Drain: PARKS AT SPRINGMILL DRAIN **Drain #:** 294
Improvement/Arm: PARK MEADOWS - SECTION 5
Operator: JOH **Date:** 2-23-04
Drain Classification: Urban/Rural **Year Installed:** _____

RE: The Parks @ Springmill Drain-Park Meadows-Section 5 Arm

Re: Parks at Springmill: Park Meadows Sec. 5

Drain Name: Park Meadows Sec. 5

STORM SEWER PLAN & PROFILES

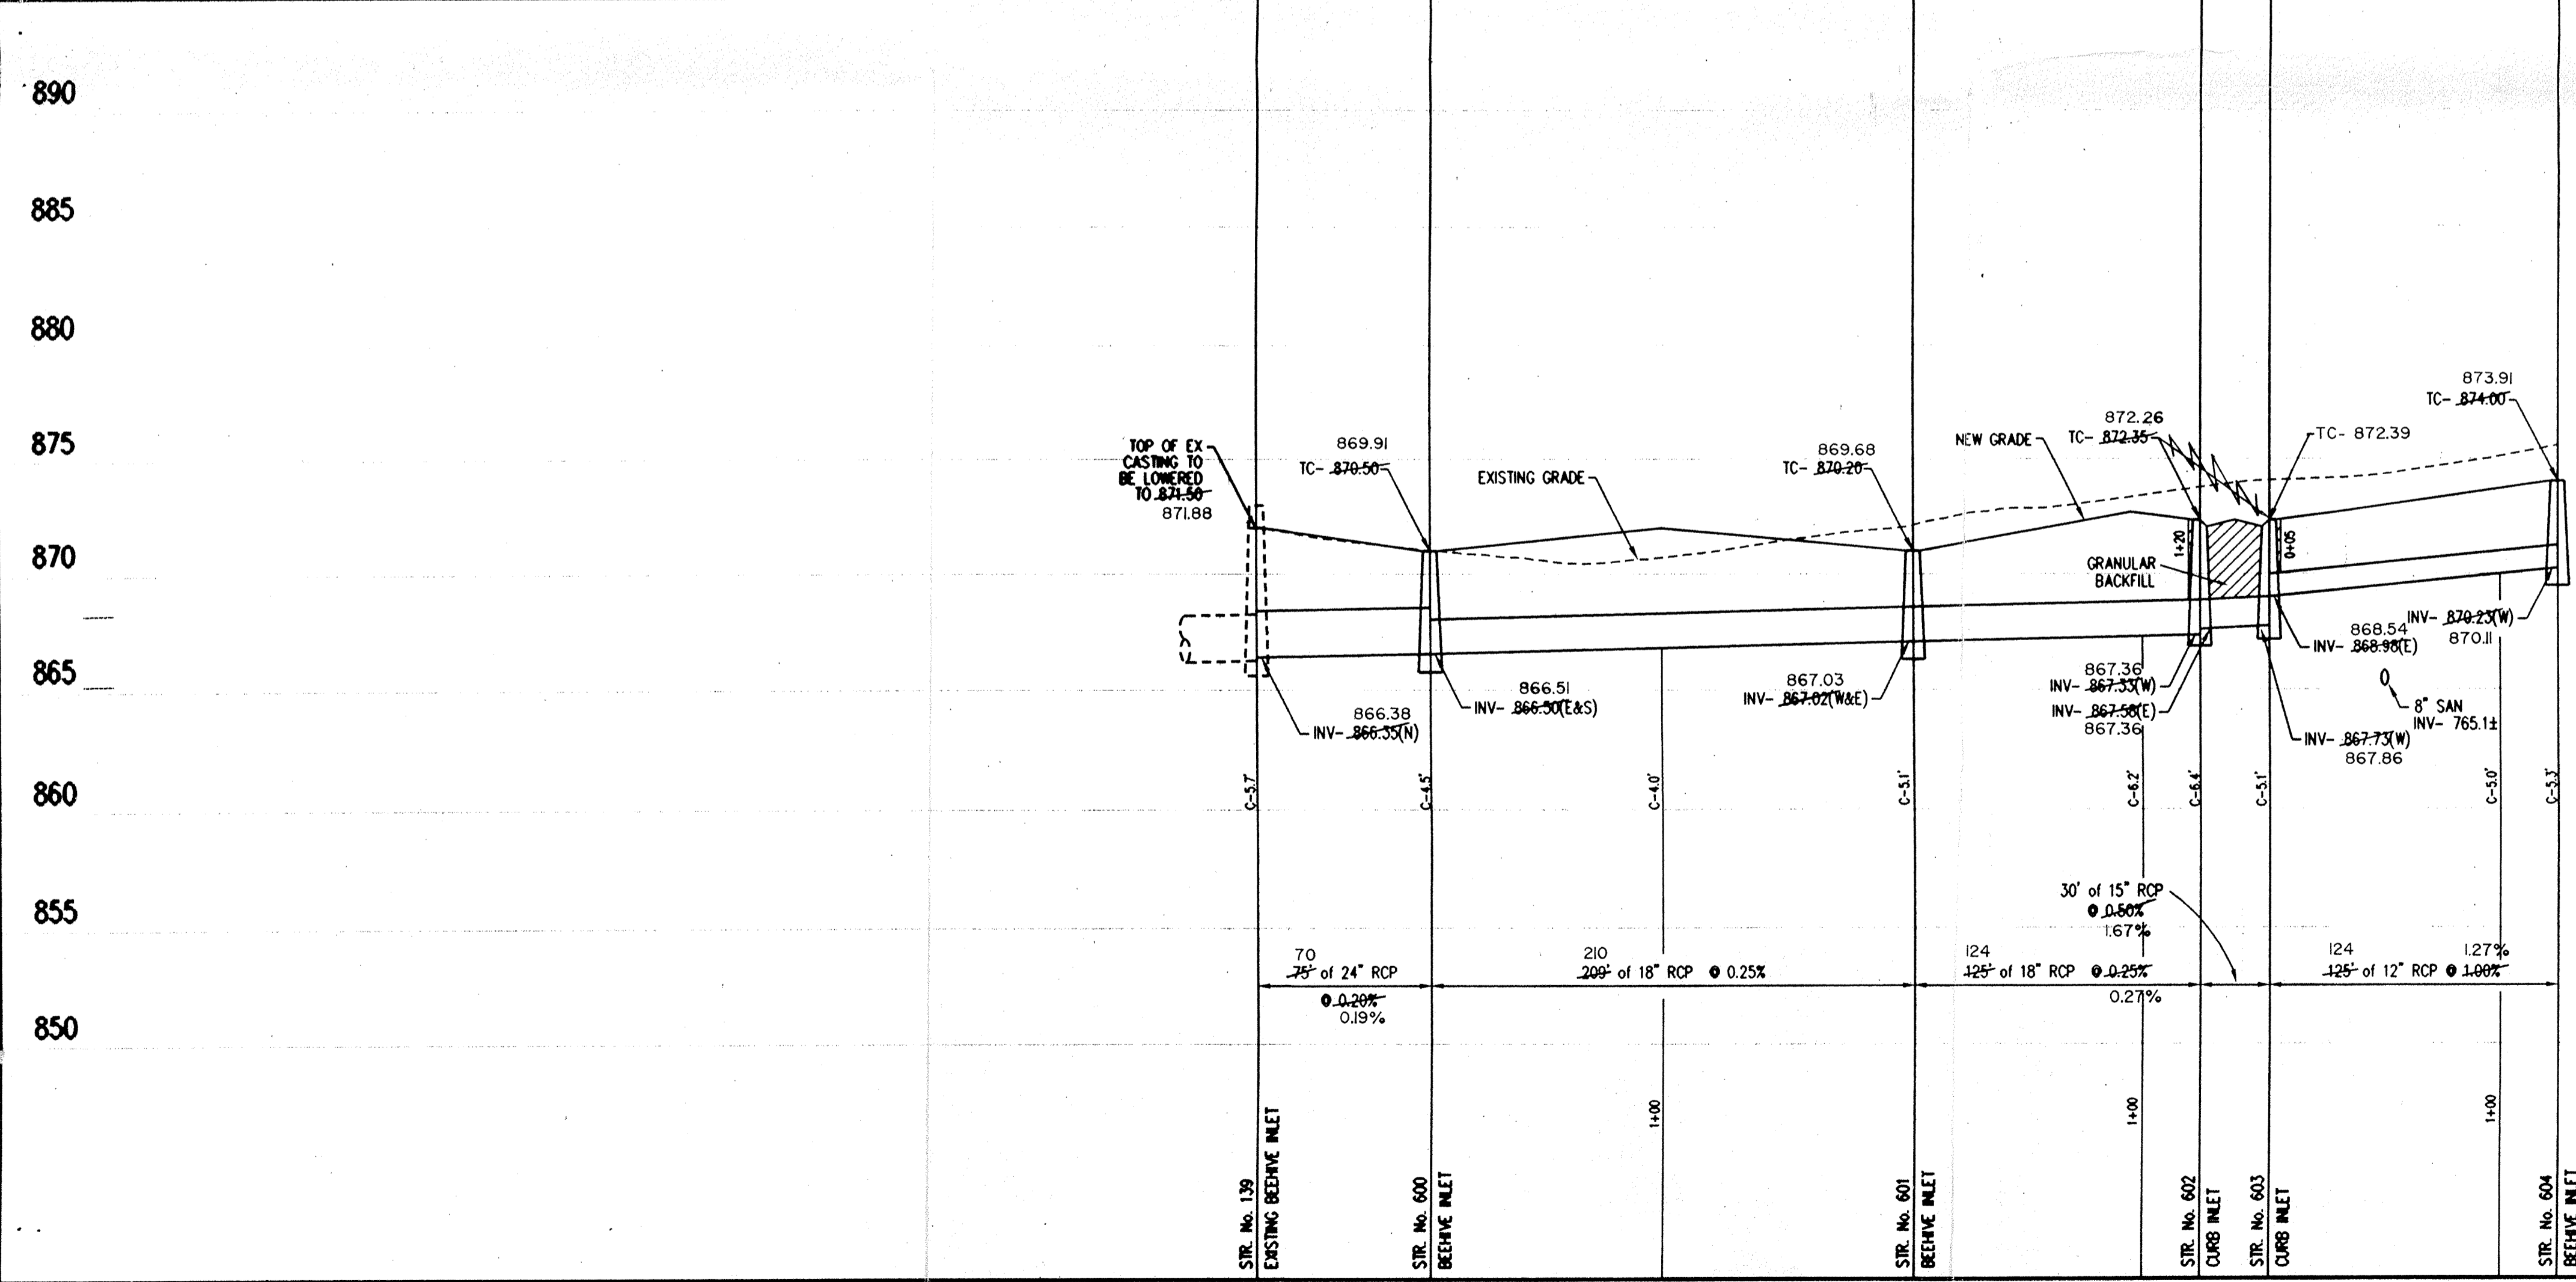
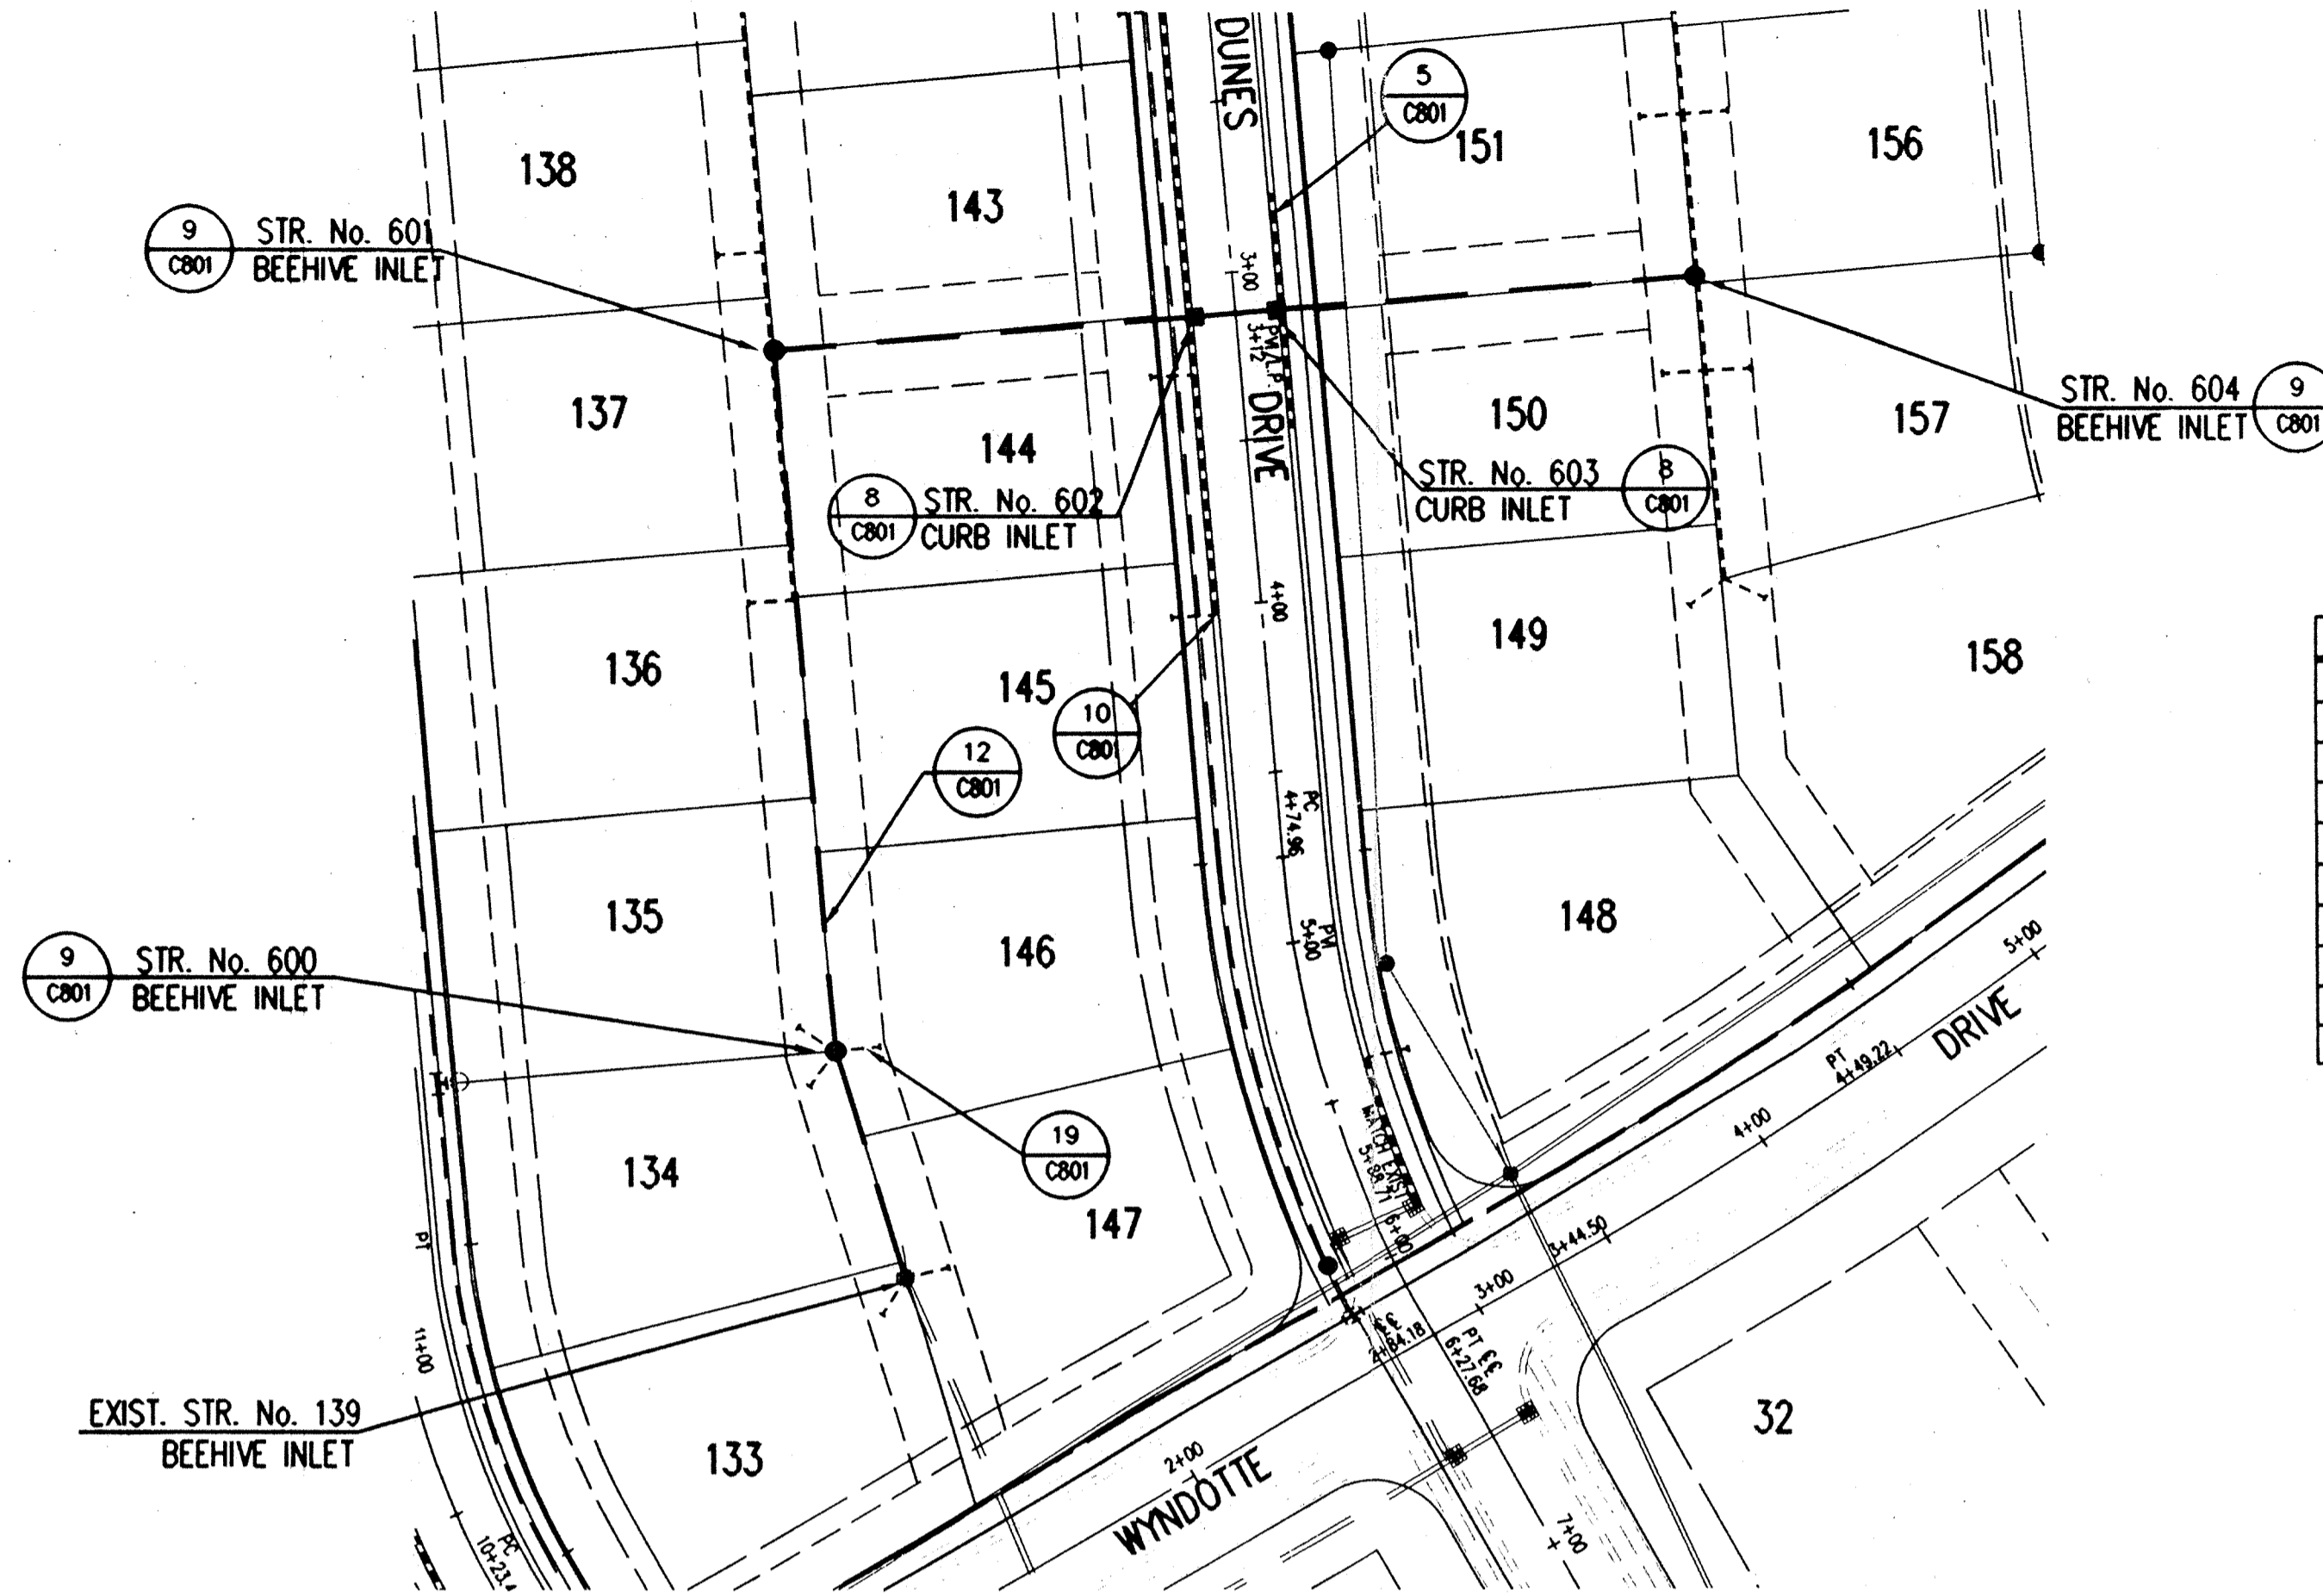
During construction, changes were made to the drain which will alter the plans submitted with my report for this drain dated December 19, 1997. The changes are as follows:

Structure:	T.C.:	I.E.:	Pipe:	Length:	Original Plans:	Difference:
EX. STR. 139	871.88	866.38				
600	869.91	866.51	24	70	75	-5
600	869.91	866.51				
601	869.68	867.03	18	210	209	1
601	869.68	867.03				
602	872.26	867.36	18	124	125	-1
602	872.26	867.36				
603	872.39	867.86	15	30		
603	872.39	868.54				
604	873.91	870.11	12	124	125	-1
608		865.86				
609	868.53	866.03	18	21	25	-4
609	868.53	866.03				
610	869.49	866.39	18	151	152	-1
610	869.49	866.39				
611	869.54	866.71	15	30		
607	874.95	872.02				
606	874.95	871.74	12	30		
606	874.95	871.74				
605		870.87	15	156	163	-7

The length of the drain due to the changes described above is now **3,440 feet**.

Map Correction-Field Verification

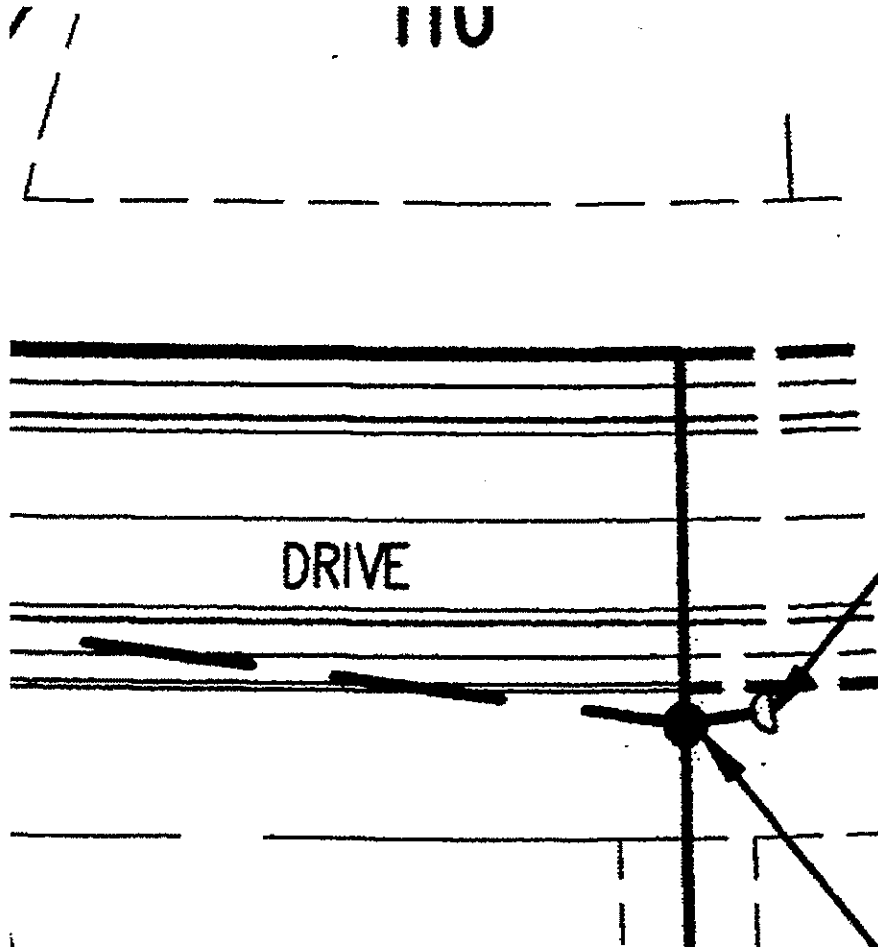
The 12 feet of 18" RCP between Structures 133A to 133 was removed with the development of Park Meadows Section 4.

*Removed with
Park meadows Sec. 4*

New Length: 6021.55
